**EQUIPMENT INSTALLATION ONLY. Veterans Memorial Ice Rink,
Mechanical Improvements**

ADDENDUM NO. 1

January 8th, 2018

PROJECT	WALTHAM VETERAN'S RINK
WALTHAM, MA REFRIGERATION AND DEHUMIDIFICATION IMPROVEMENTS	
DRAWING TITLE	POWER FEEDER

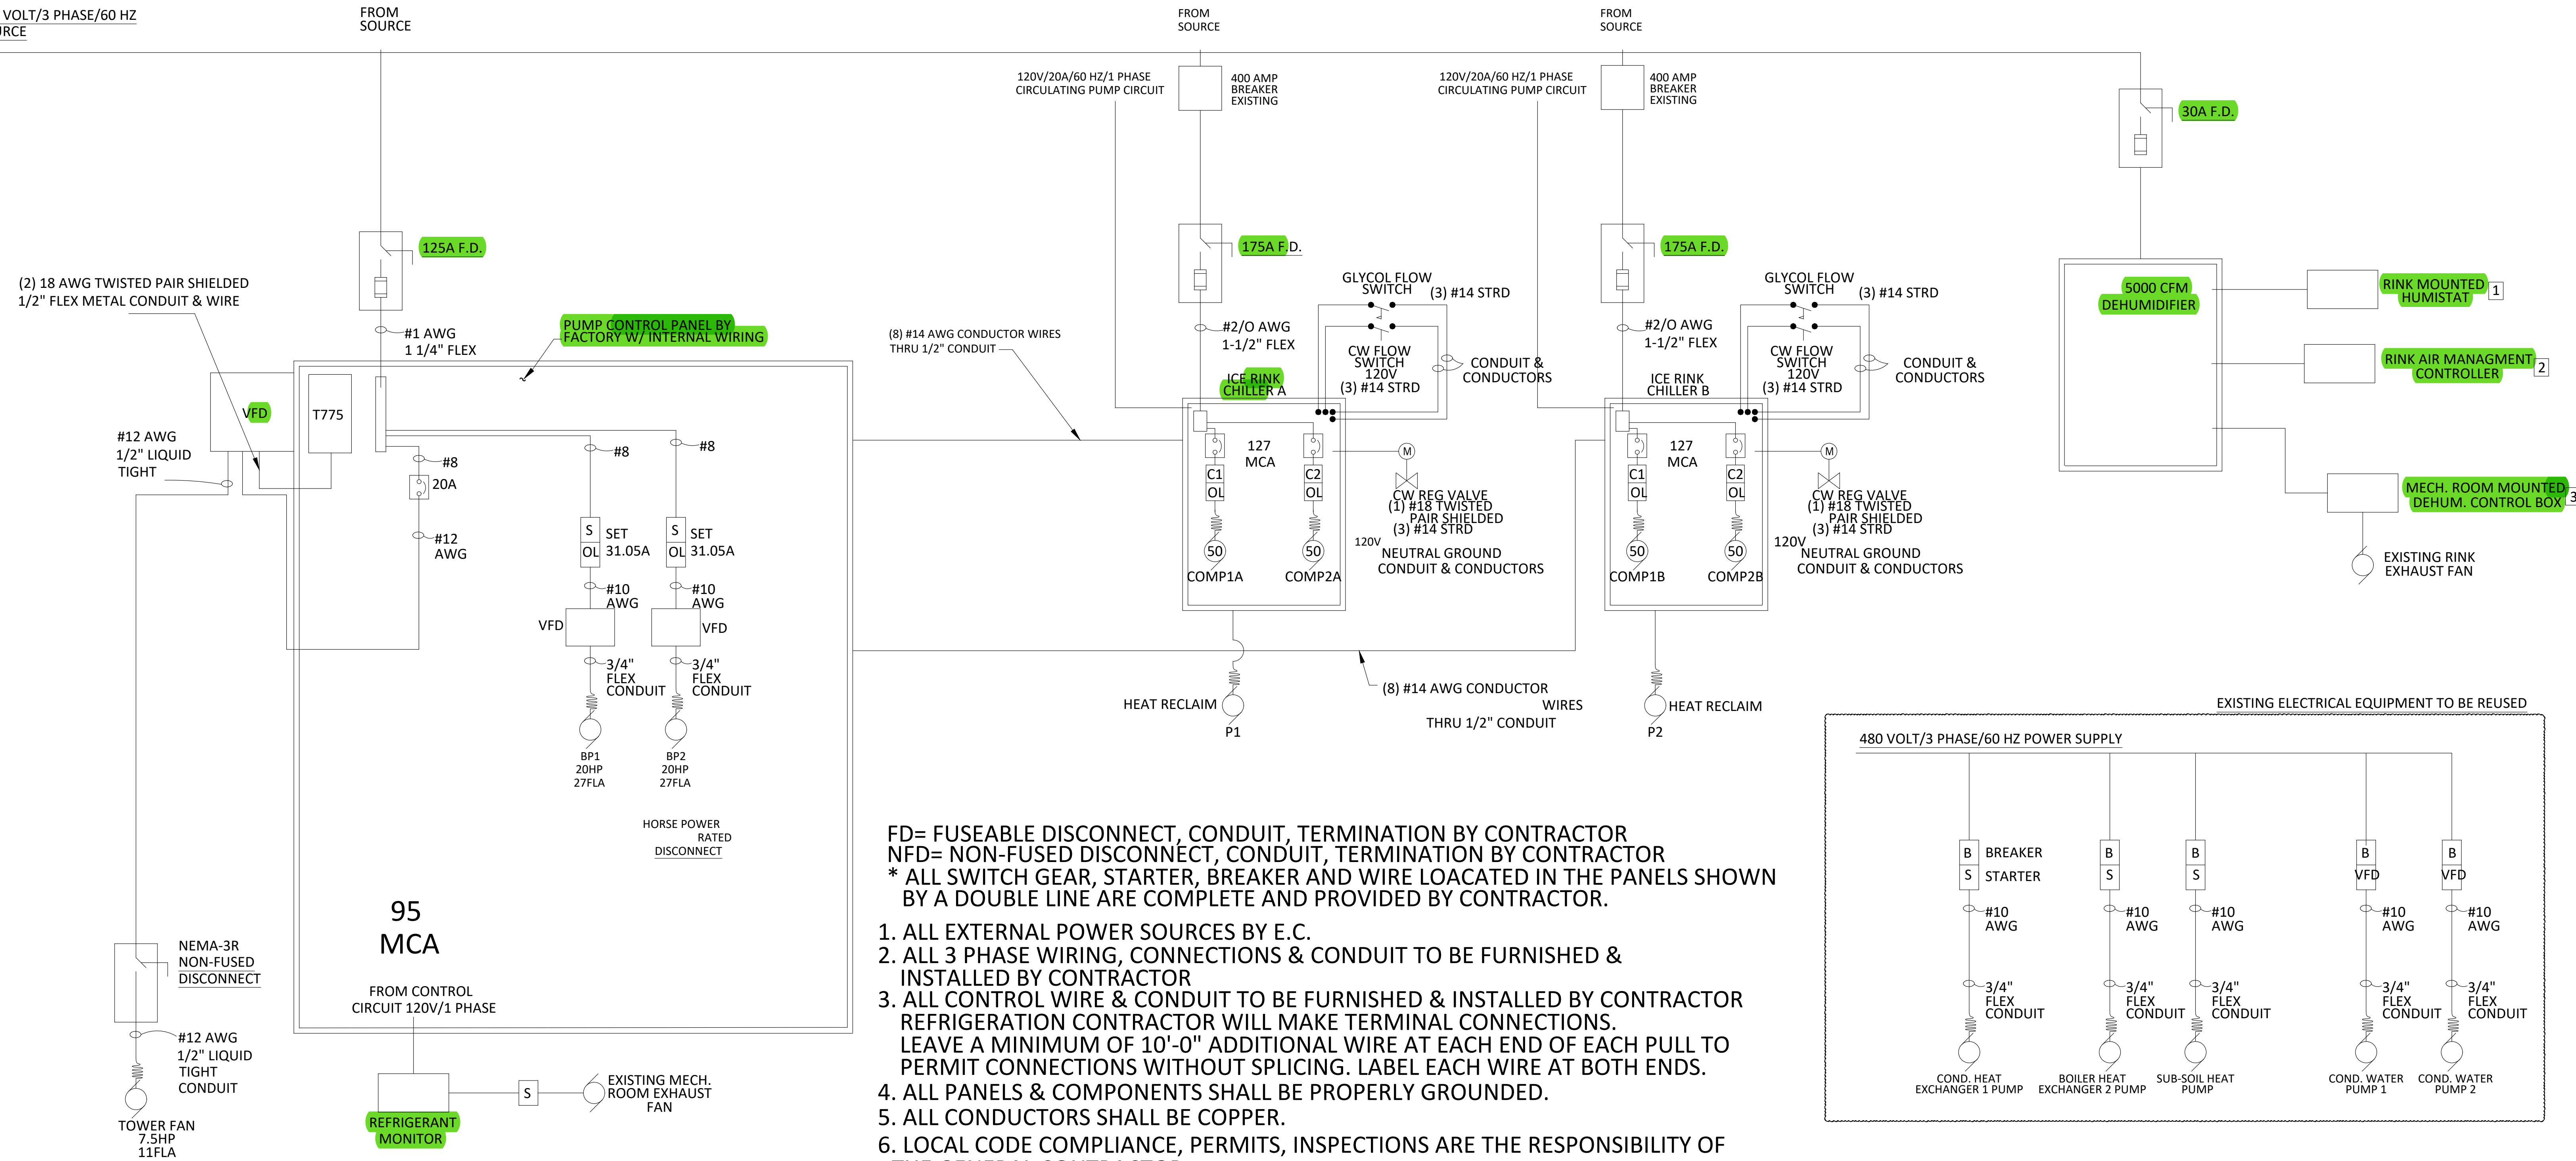
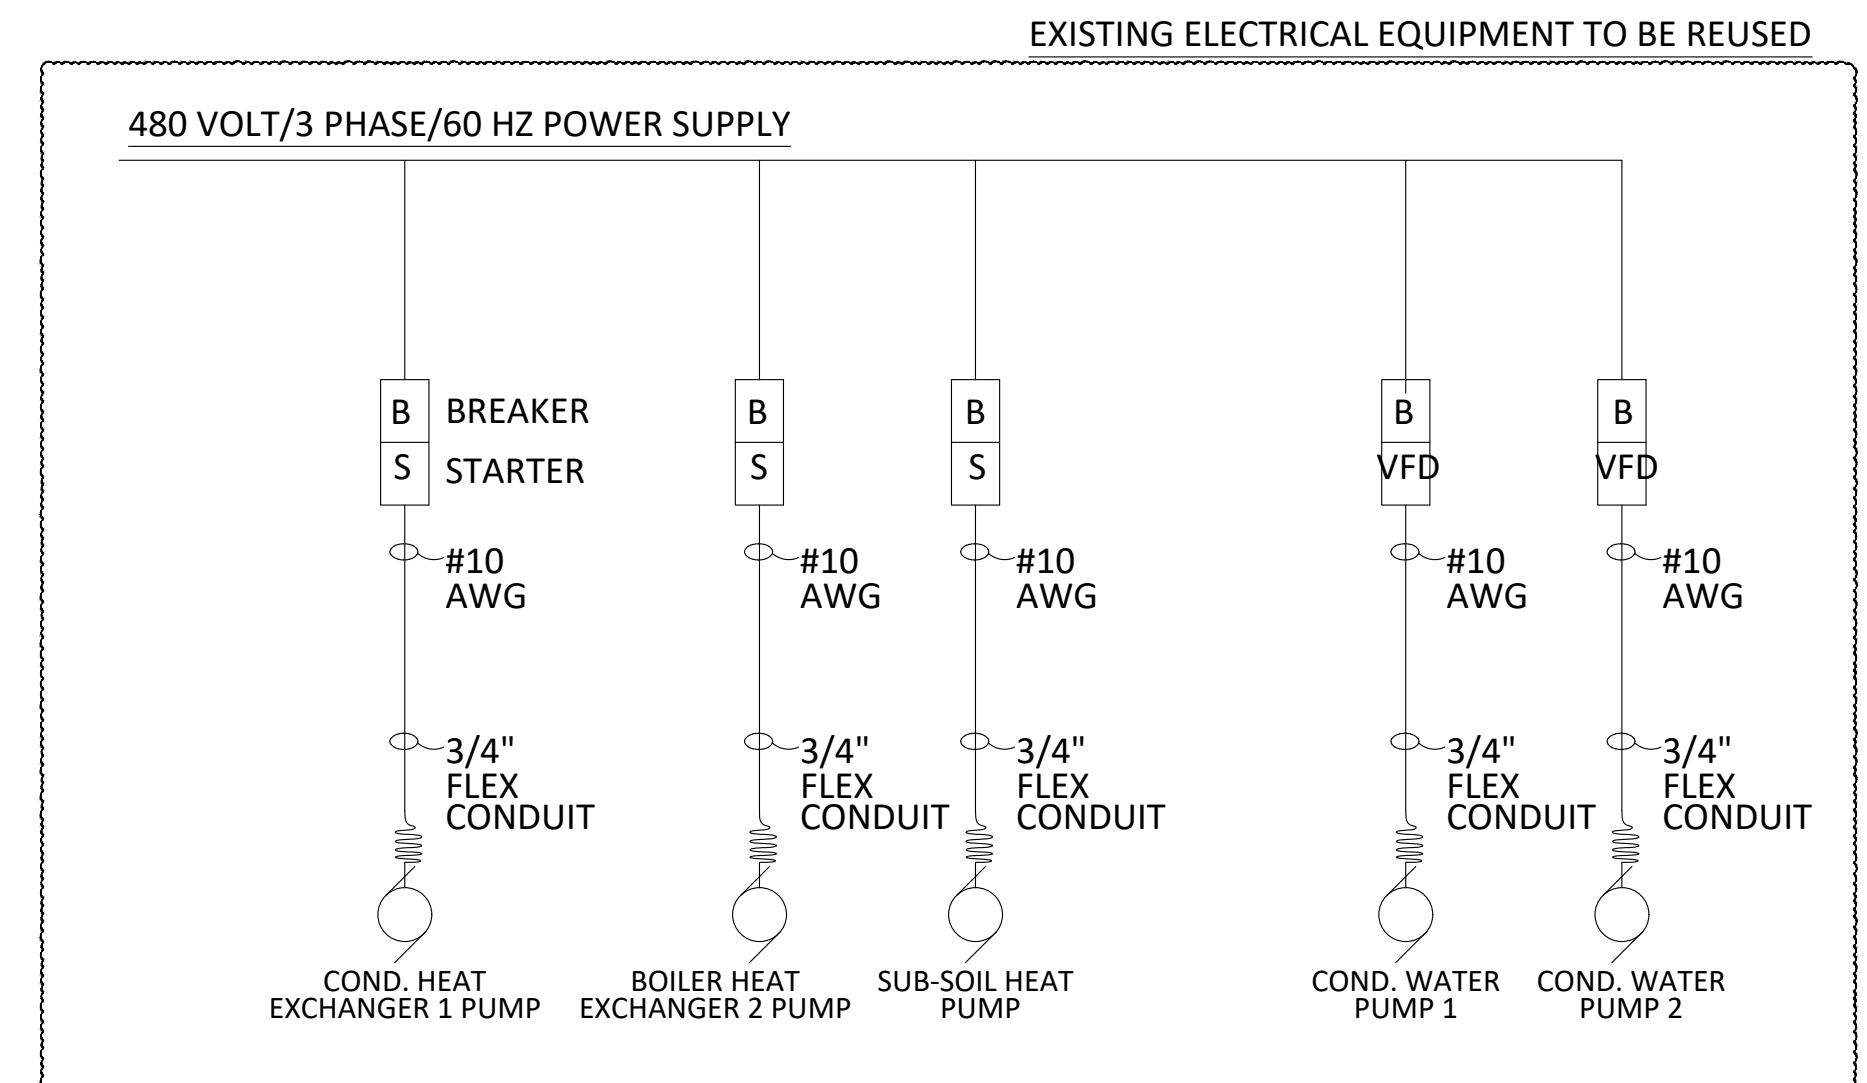
Revision date 01-02-2018.
 Highlighted to depict demarcation between factory and field electrical

CONDENSER WATER

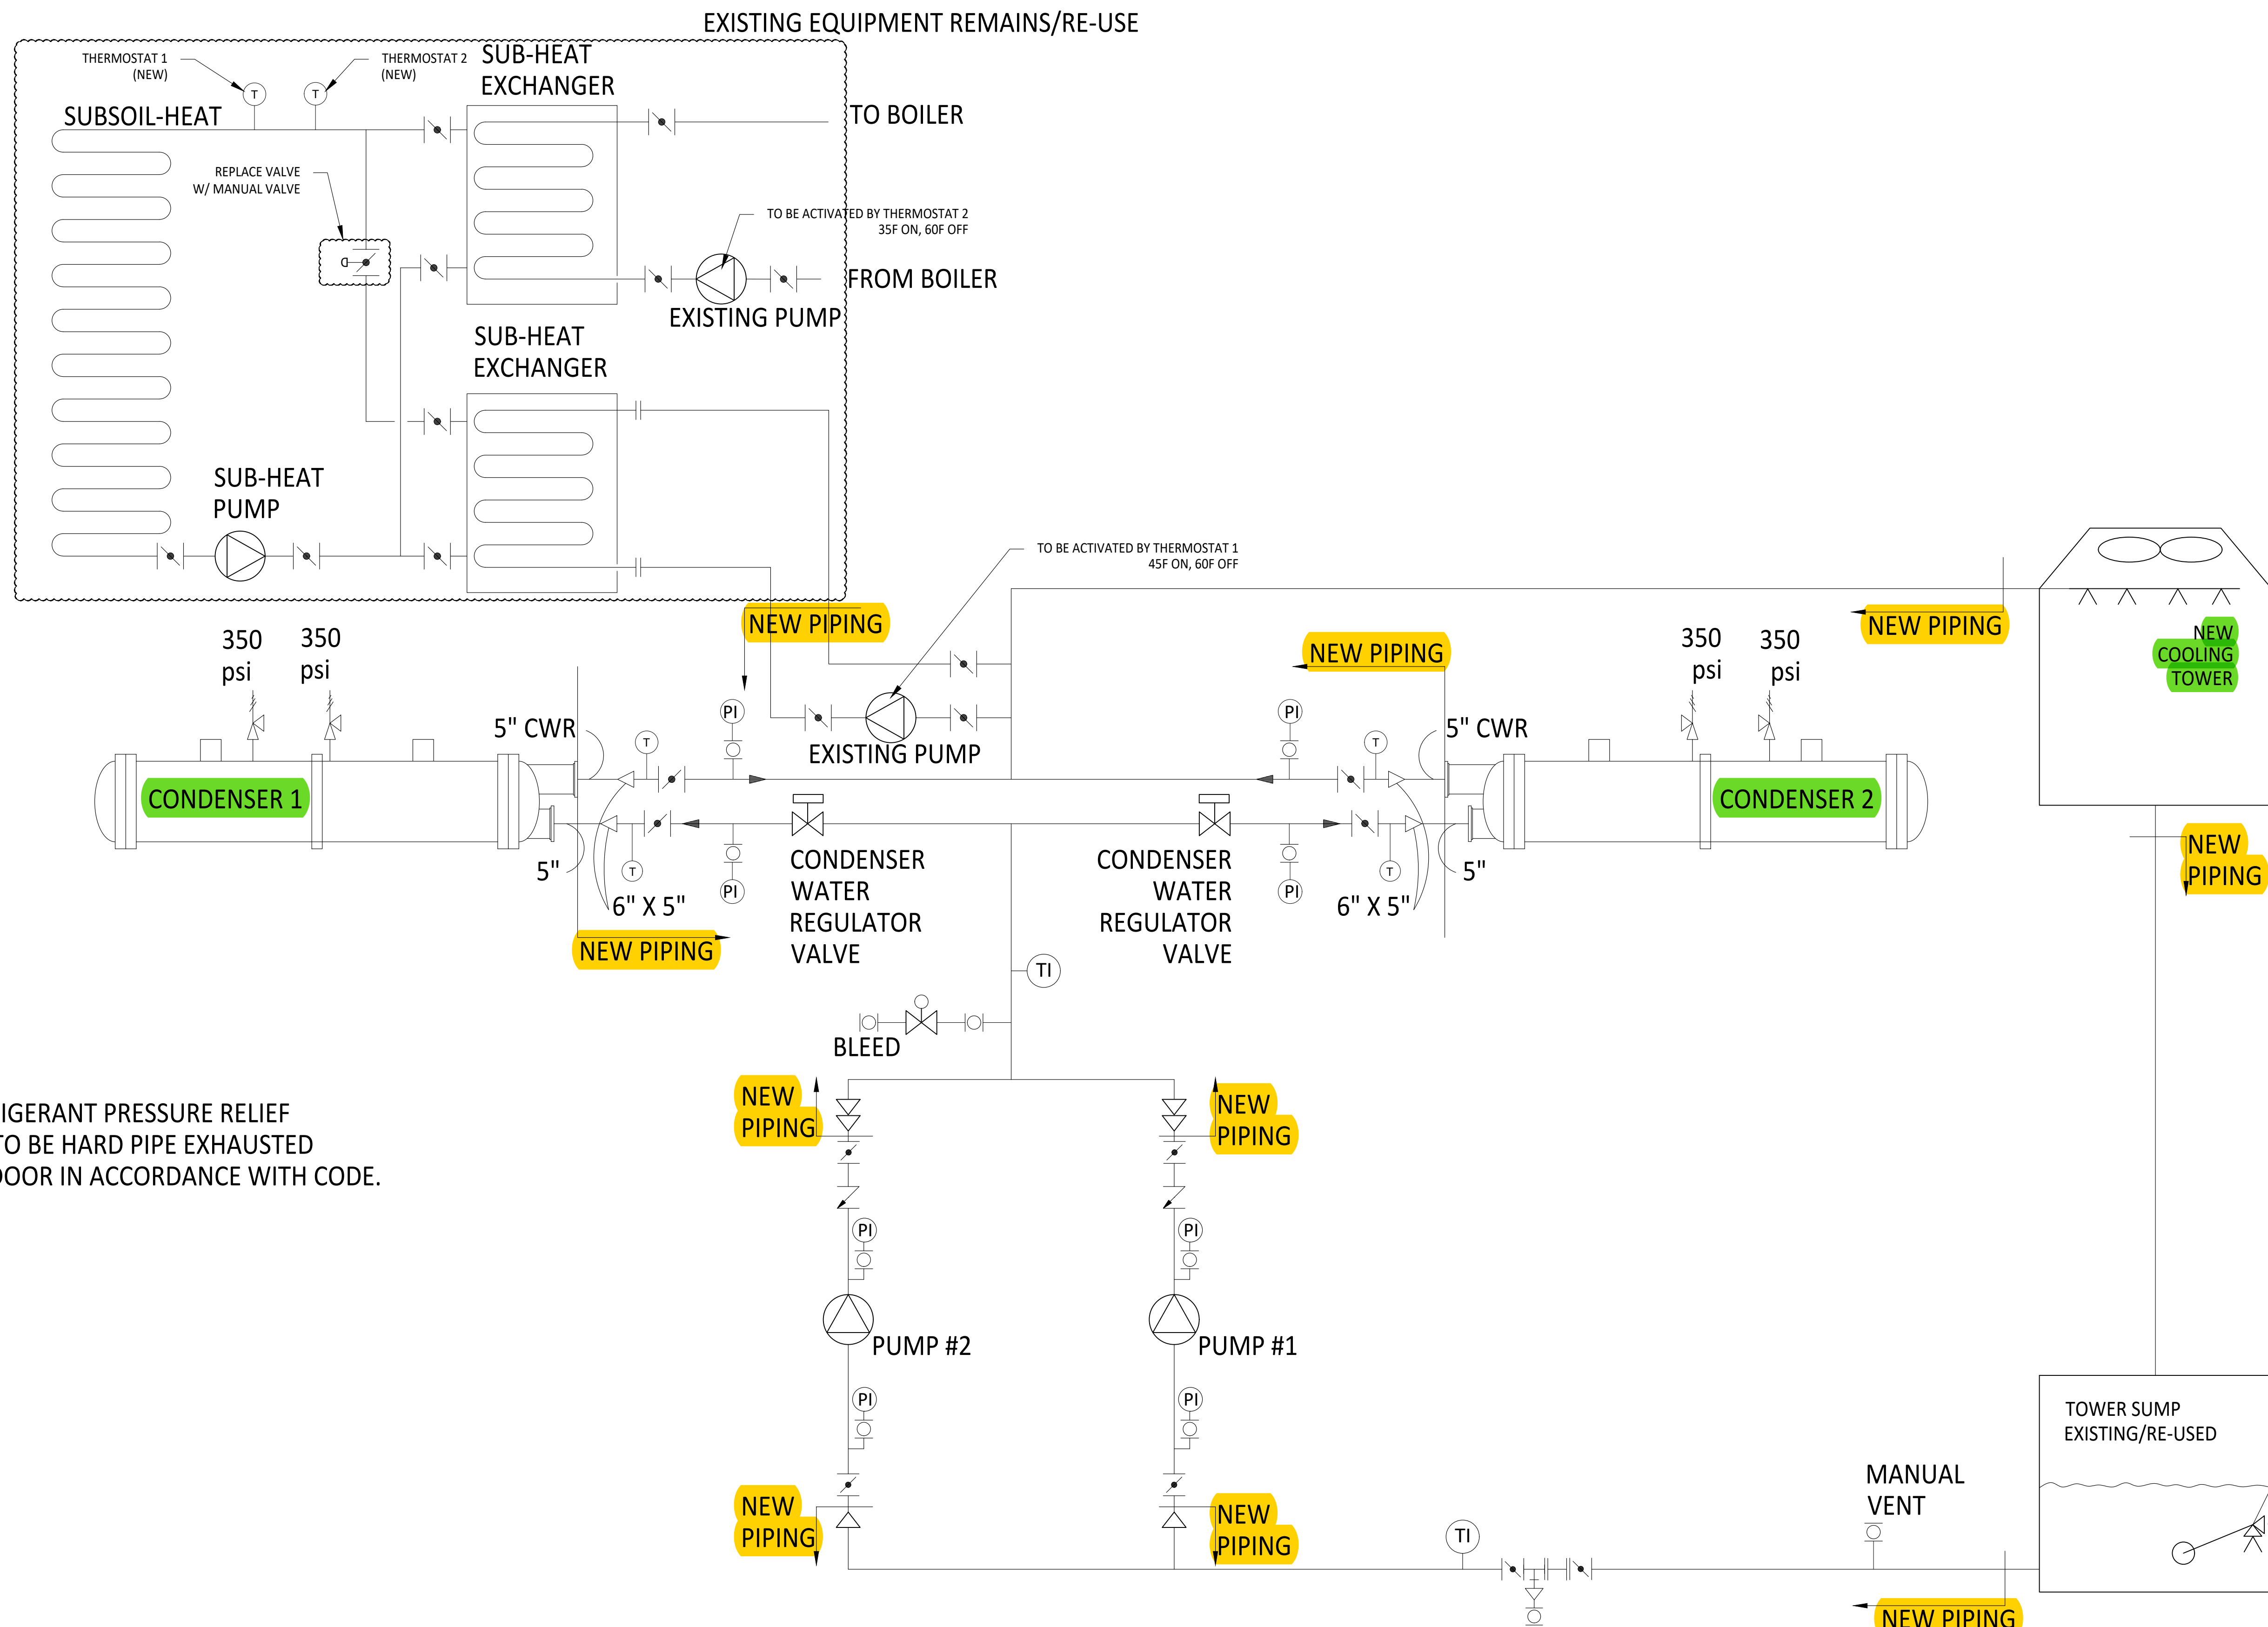
Revision date 01-02-2018.
Highlights to depict demarcation between factory and field piping.
